Final Environmental Statement

related to the operation of the
Teton Uranium ISL Project

Docket No. 40-8781

Teton Exploration Drilling, Inc.

Fig. 2.5. Schematic of a typical injection and recovery well completion at the Teton-Nedco project site.

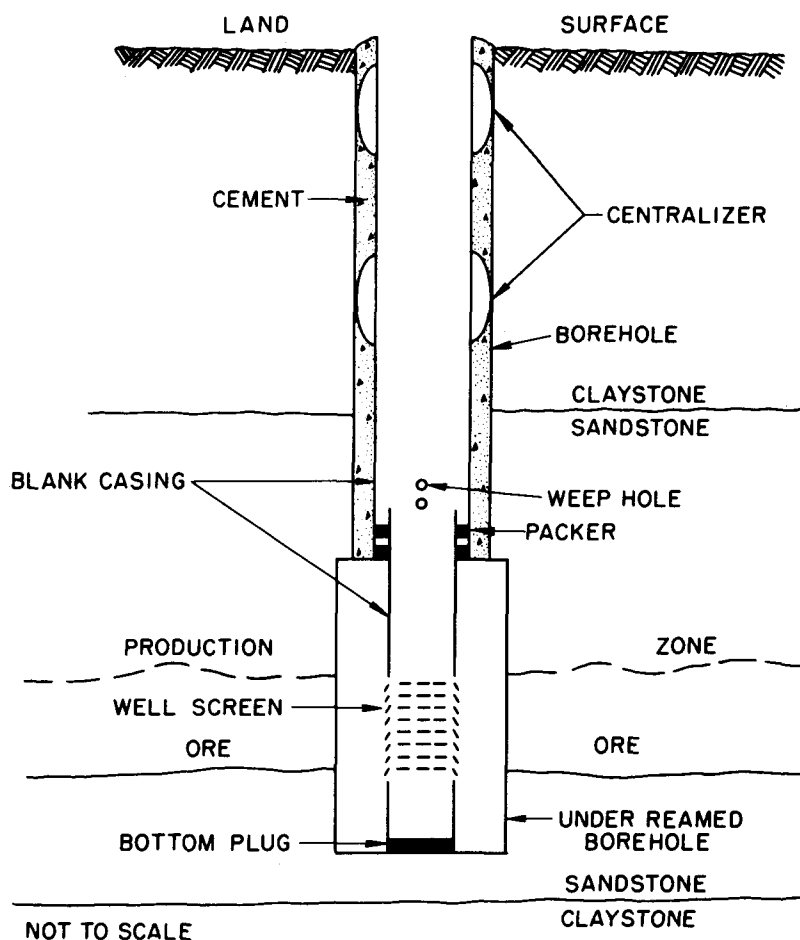
5. Page 2-41. What is the purpose of the weep hole on Figure 2-5? Is it located in the tubing or casing? If located in the tubing then the injection pressure will be transmitted to the monitoring annulus and any annulus pressure will only be monitoring injection pressure. If the weep hole is in the casing and the packer fails the lixiviant will migrate through the weep hole into zones above the ore zone.

Fig. 2.7. Uranium recovery process flow sheet for the Teton-Nedco facility.

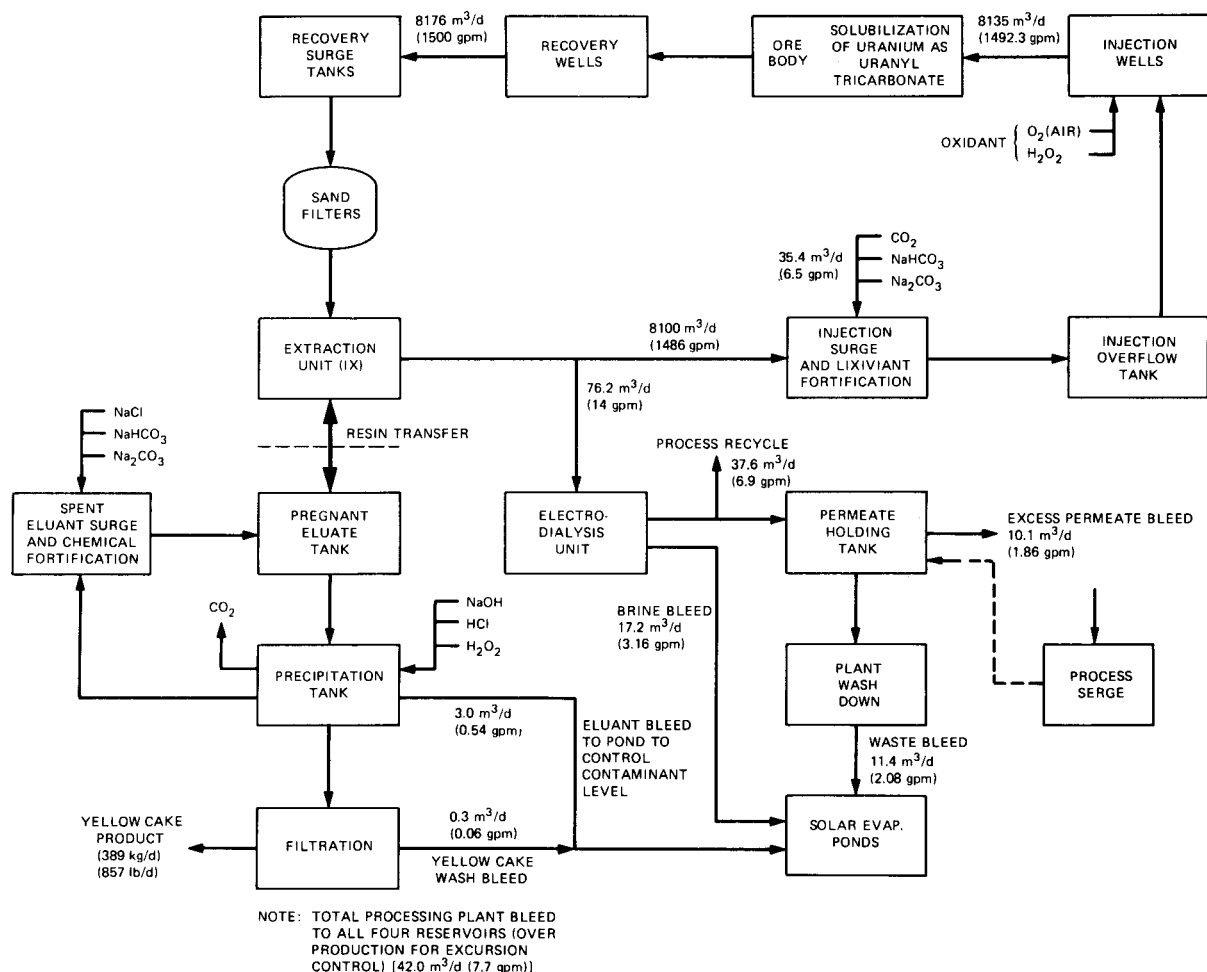
6. Page 2-47. Figures 2.7 displays a flow sheet in which the recovery wells take in 7.5 gpm more than the injection wells, thus 7.5 gpm builds up in the system. However, only 5.84 gpm are shown going to the evaporation ponds. How is the missing 1.66 gpm, 2390 gallons per day, accounted for?

6. Figure 2.7 shows 5.84 gpm going to evaporation ponds and 1.86 gpm to the process surge tank for a total of 7.7 gpm. The process surge water will be ponded for future process (thus the dashed line) or will be reinjected during restoration. The total amount reinjected has been corrected from 1492.5 to 1492.3 gpm.

Fig. 2.8. Water balance for the Teton-Nedco project based on 80% efficiency of the electrodialysis unit.

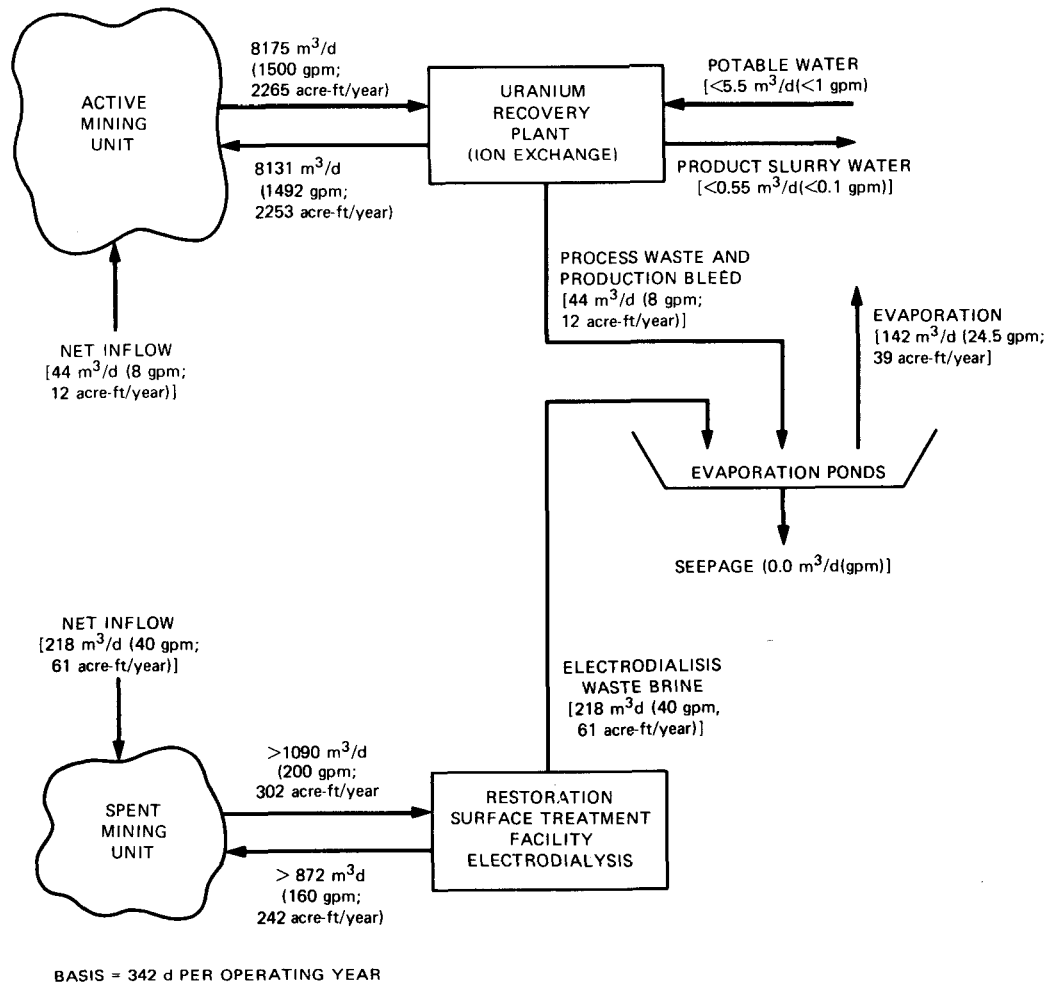
7. Page 2-53. Figure 2.8 suggests the evaporation ponds will evaporate 26 gpm, yet we could find no evidence in the document supporting this rate. How large are the evaporation ponds? Does the pond design consider the low evaporation rate during the winter? A table or summary of potential evaporation rates for the site area should accompany the document.

7. The evaporation rate for the Converse County area is approximately 44 in. per year; an average rainfall of about 12 in. yields a net evaporation of 32 in. per year (Weather Atlas of the United States, United States Department of Commerce, 1968 - Reprinted 1975). This evaporation rate over 14.8 acres is equal to 39.5 acre/ft/year or 24.5 gpm. Figure 2.8 has been corrected to show an evaporation rate of 24.5 instead of 26 gpm.
